SUBJECT : ImageQuest Co., Ltd.
FCC ID: PJIL15A0C063
Class II Permissive Change
Orig. Grant Date: March 11, 2003

Transmitted herewith, on behalf of ImageQuest Co., Ltd. is an application for a Class II Permissive Change Certification of the following 15-inch LCD Monitor:

FCC ID : PJIL15A0C063
Model : L15A0C063

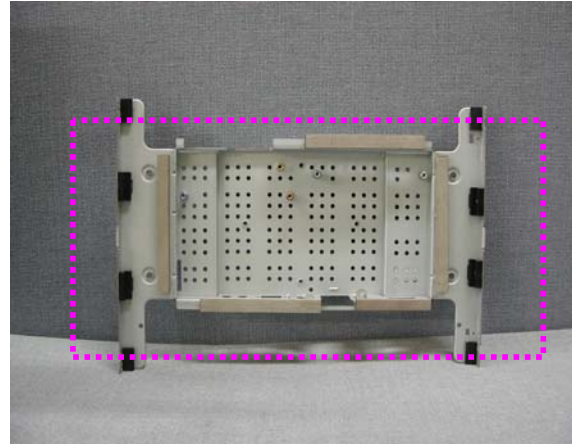
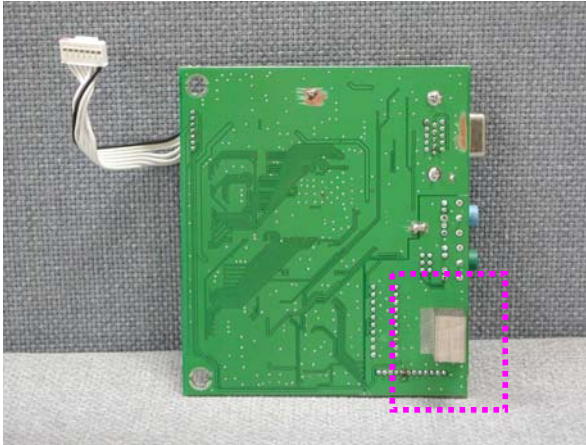
1. Attach a gasket on the Main Board and Main Frame to contact a LCD panel

2. Attach a gasket on the Stand ass'y to contact a LCD panel

3. Attach a aluminum foil on LCD panel

4. Apply a ferrite Core to the OSD board signal cable
